Buena Vista Coalition SDEAR Work Plan

Proximity to Surface Waters

Buena Vista Coalition
525 North Main Street
Buttonwillow, CA
April 15, 2016

The Buena Vista Coalition (BVC) did receive the Conditional Approval in a letter dated November 5, 2015 from the Report submitted February 4, 2015. In the CVRWQB letter there was additional work requested to secure an unconditional approval. Below is a review of the comments requiring additional work by the BVC. Subsequently, the Regional Board required a Work Plan to address the issues of Proximity to Surface Waters. Although this Work Plan is separate it showed by viewed in conjunction with the Water Quality Management Plan, Main Drain 2012. Any water leaving a grower's field reaches the Main Drain Canal, and thus has been monitored as a part of that Management Plan, as well as the prior years leading to the development of that plan.

DISTRICT DRAINS

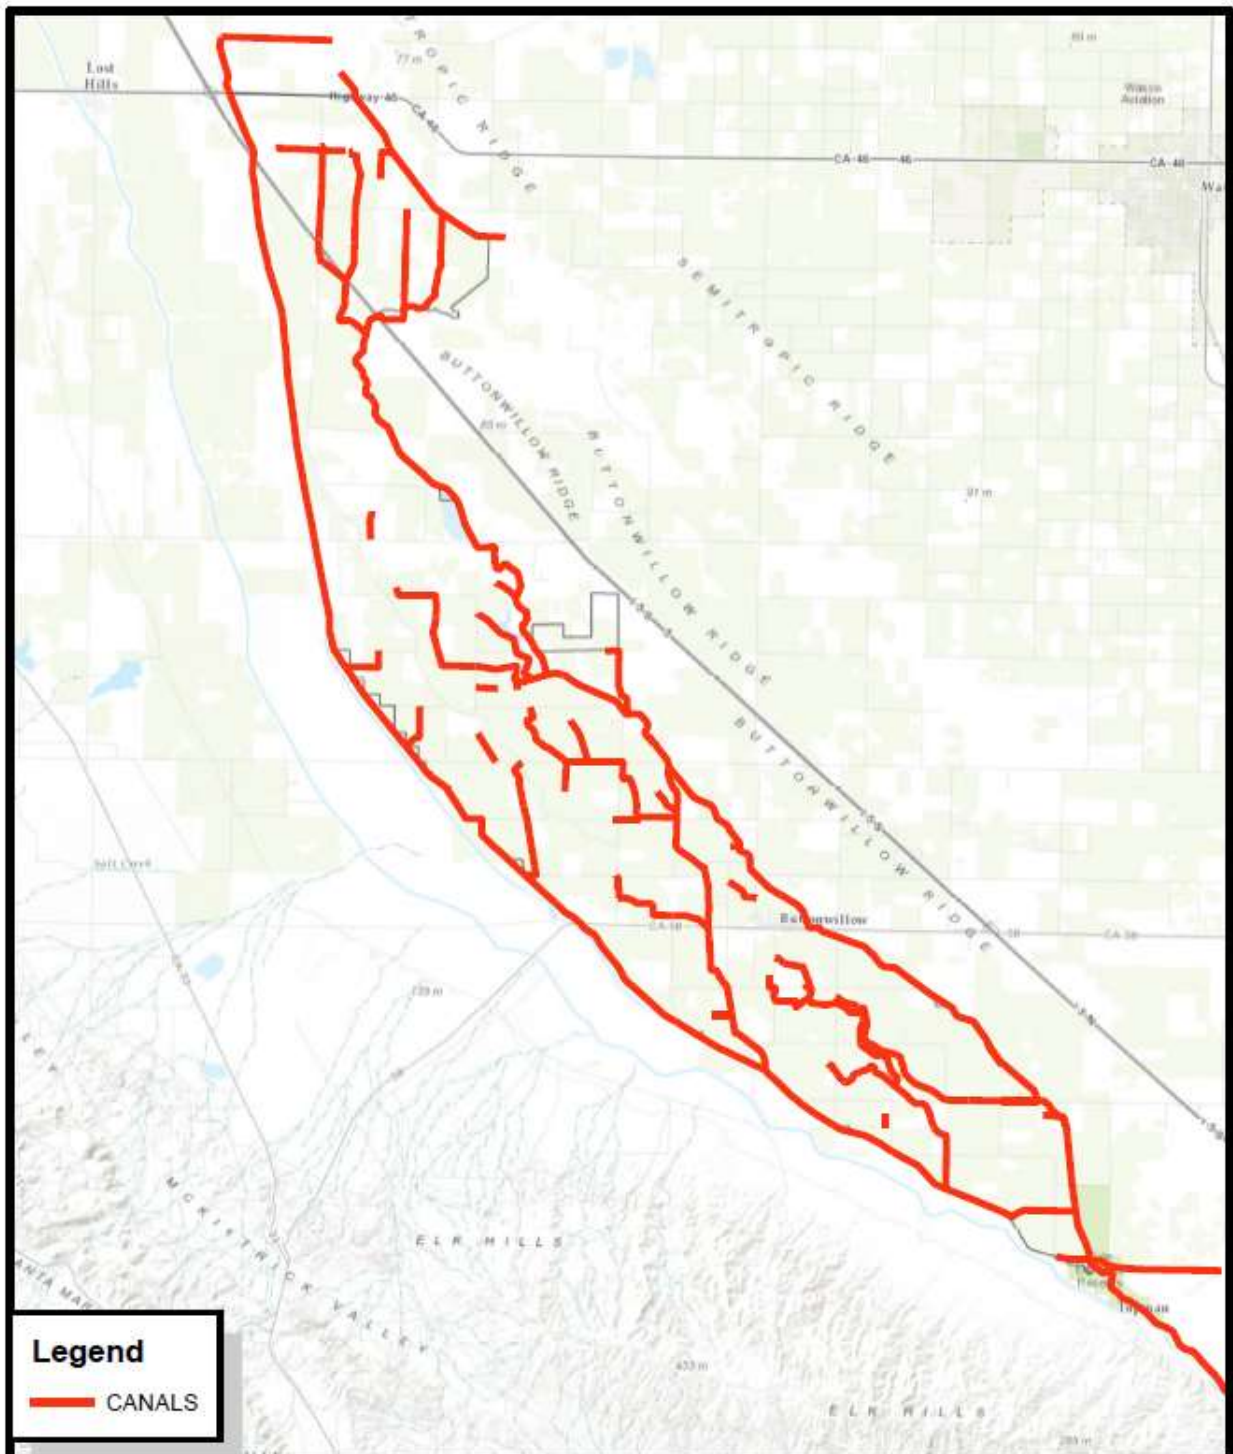
As the irrigation system was built back in the 1870's, long before pumps, supply canals all were built at elevations above the farmland, so water could gravity flow onto the fields for irrigation. The irrigation system continues to operate this way, so field water cannot flow back up into the canals, it can only flow down into the drains. Attached are plans showing the BVWSD Drains, BVWSD Canals, and the BVWSD Canals and Drains combined.
